BANKSTOWN CITY COUNCIL

SITE: Lot 4, 5 and 6 in DP 19650, Nos. 1, 3 and 5 The Crescent, YAGOONA

S96(2): Modification to the basement, internal vehicular access ramps, redesign of the residential units to the southern end of each floor and minor modifications to the internal unit designs

FILE NO: DA-1236/2010/1

PLANS - FLOOR PLAN 02

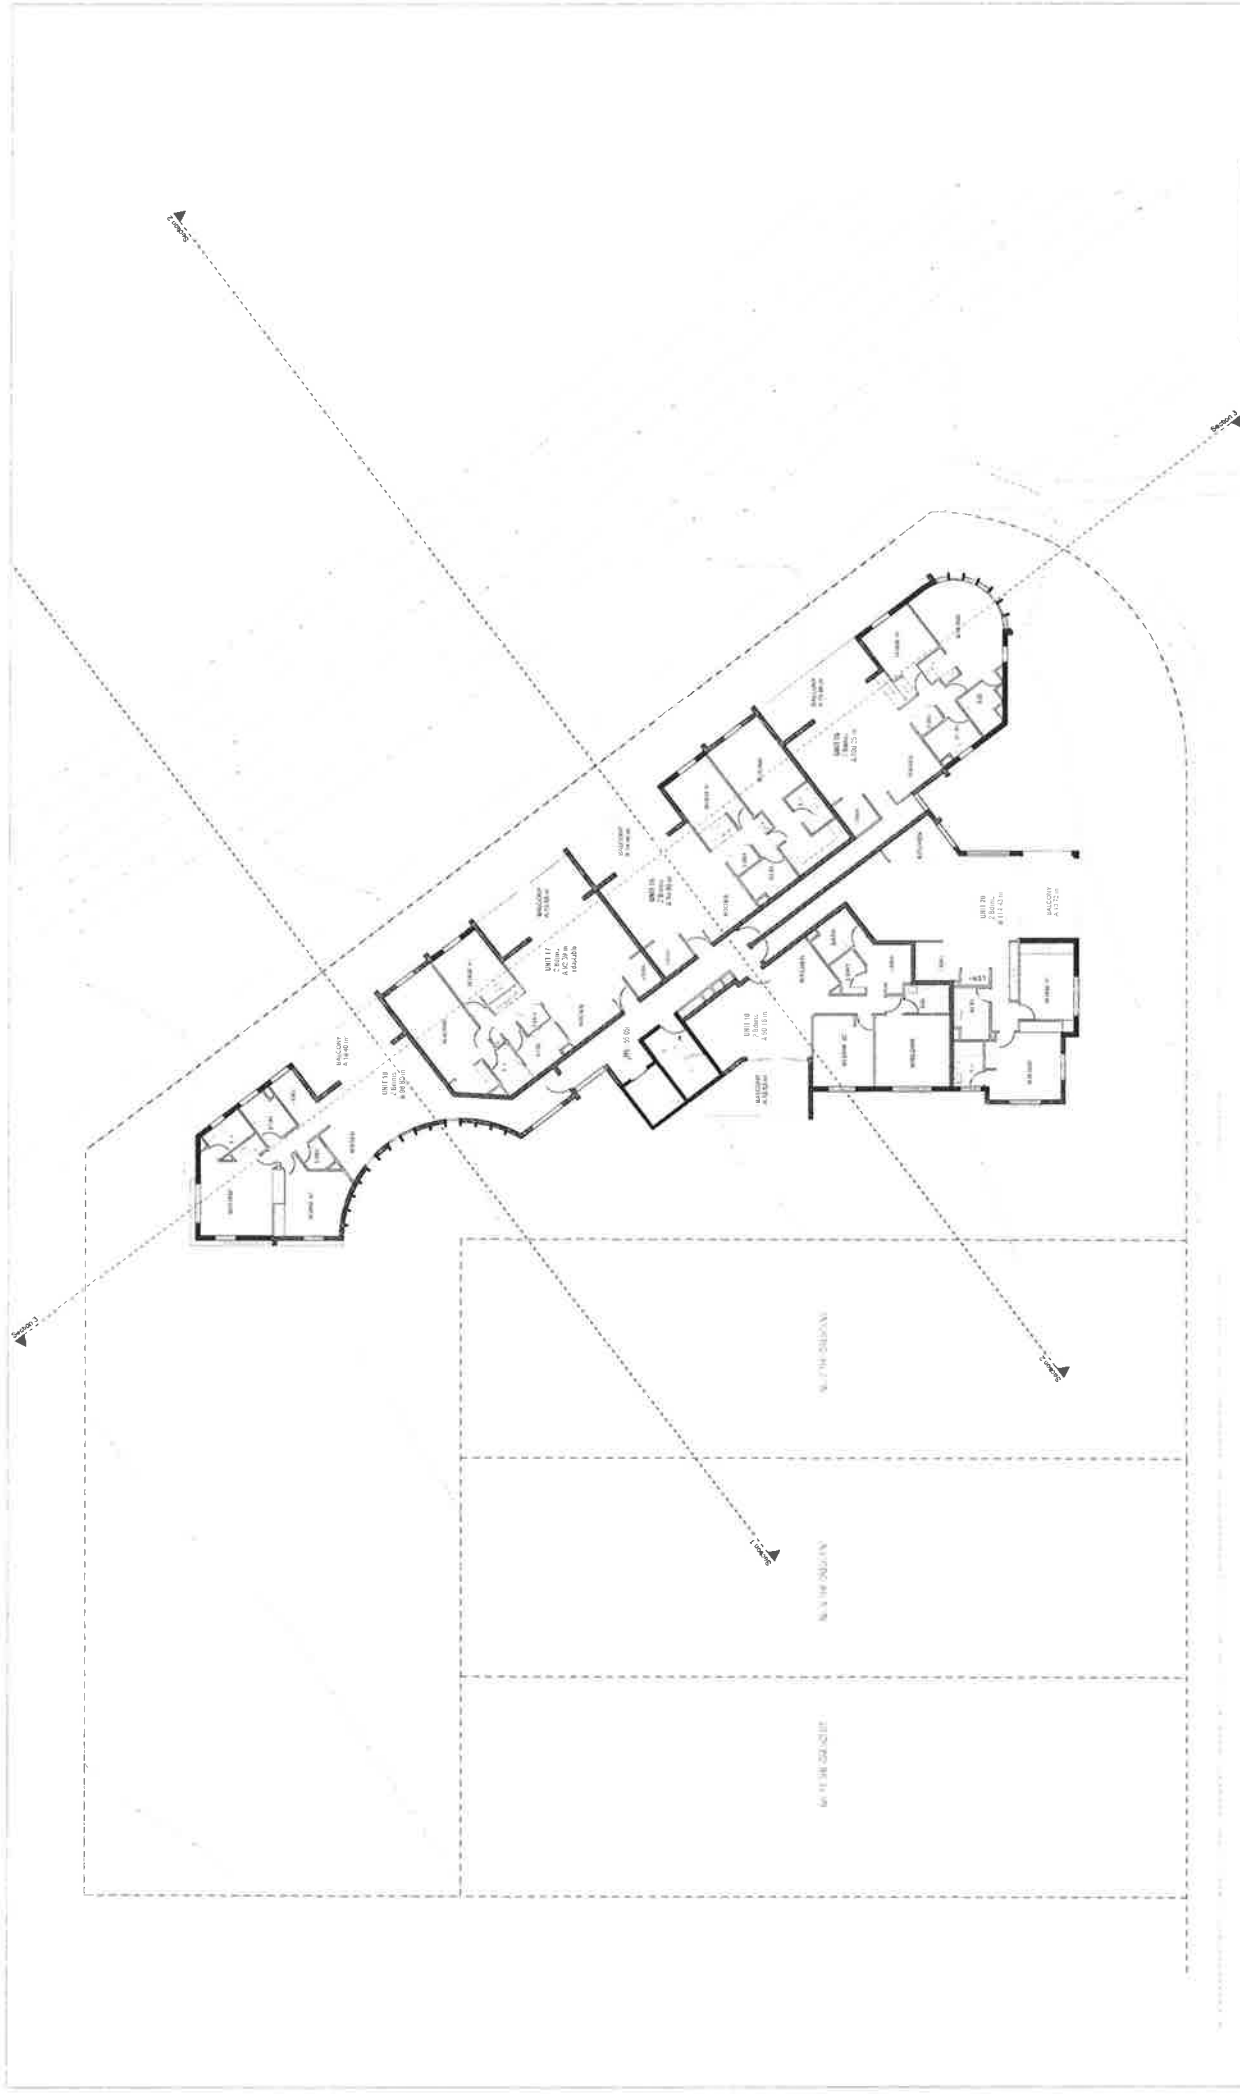
Proposed Modification:	Reason for change:
Amendments to Internal units Layout (see details below); Lobby area reduced; Lift relocated; Northern fire exit relocated; Southern fire stairs deleted.	A consequence of basement changes and fire exit deletion.
Ground – Fifth Floor (Unit changes)	
Units 01, 06, 12, 18, 24 and 30:	<ul style="list-style-type: none"> • Entry door moved closer to lift/ fire exit to satisfy max. 6m distance to fire escape (BCA). • Bedroom 2 and bathroom location switched. • Window to en-suite relocated from northern Façade to North-eastern façade. • Re-design of en-suite and bathrooms to standardized dimensions. • Amendments to kitchen layouts. • Laundry relocation.
Units 02, 05, 11, 17, 23 and 29:	<ul style="list-style-type: none"> • Re-design of en-suite and bathrooms to standardized dimensions. • Amendments to kitchen layouts.

Units 14 and 20:	<ul style="list-style-type: none"> • Units redesigned to remove need for two fire stairs. • Entry door moved closer to lift/ fire exit to satisfy max.6m distance to fire escape (BCA). • Relocation of Kitchen to removed fire stairs location. • Bathroom moved to internal location. • Re-design of en-suite and bathrooms to standardized dimensions. • Bedroom 2 size increased.
Units 07, 13 and 19:	<ul style="list-style-type: none"> • Kitchen, bathroom and laundry relocation. • Re-design of en-suite and bathroom to standardized dimensions. • Addition of Walk-in-robe to master bedroom. • Bedroom 2 area increased.

Unit 26	<ul style="list-style-type: none"> • Unit redesigned to 'remove need for two fire stairs'. • Entry door moved closer to lift/ fire exit to satisfy max. 6m distance to fire escape (BCA). • Relocation of Kitchen to removed fire stairs location. • Addition of W.C. • Laundry relocated.
Unit 25	<ul style="list-style-type: none"> • Re-design of kitchen, en-suite and bathroom to standardized dimensions. • Laundry relocated.
Units 31 and 35:	<ul style="list-style-type: none"> • Area reduction to allow room for access corridor to units 32 & 36. • Relocation of kitchen.
Units 32 & 36:	<ul style="list-style-type: none"> • Unit redesigned to remove need for two fire stairs • Entry door moved closer to lift/ fire exit to satisfy max. 6m distance to fire escape (BCA). • Addition of new bedroom. • Addition of new En-suite. • Re-design of kitchen, en-suite and bathroom to standardized dimensions.
Units 1, 6, 12, 18, 24, 30:	<ul style="list-style-type: none"> • New external windows associated with the proposed new study area (all windows are in the eastern elevation overlooking the rail corridor).
